Eva Fryar
Stepping Stone Homes
Lot 32 Fox River Falls
Menomonee Falls, WI

The location, materials, and plans for your 4' black aluminum fence have been reviewed and approved pursuant of the Declaration of Restrictions for Fox River Falls by the Architectural Control Committee. We approve of the locations as marked on the survey staying two feet off all lot lines. We approve of the installation in the storm sewer and drainage easement area as you received permission from the Village of Menomonee Falls. The fence cannot obstruct the drainage flow.

1 ALUMINUM FENCE

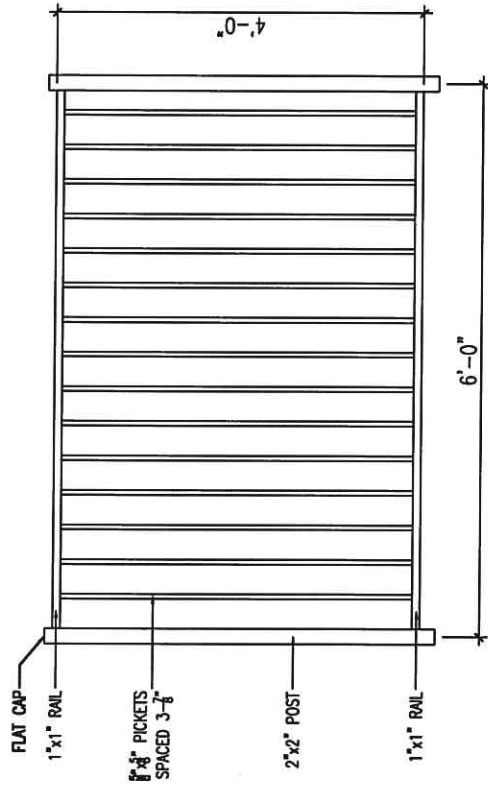
This is a private drainage easement so a fence would be allowed as long as the drainage isn't obstructed.
